Release Note

Edgecore EAP104 Release v12.4.9

Document # EAP104-v12.4.9-1299-2b7f49c10

Enhancement from v12.4.7-1135-6ec7b9dd5

1.1 OpenRoaming Enhancement

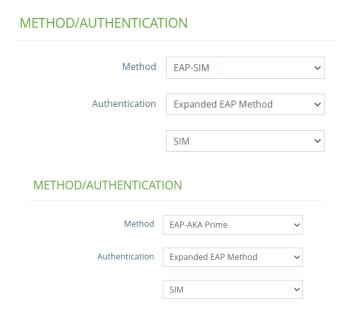
Method modification in the OpenRoaming page.

- 1. Support EAP-SIM in NAI Realm List.
- 2. Modify EAP-AKA to EAP-AKA Prime
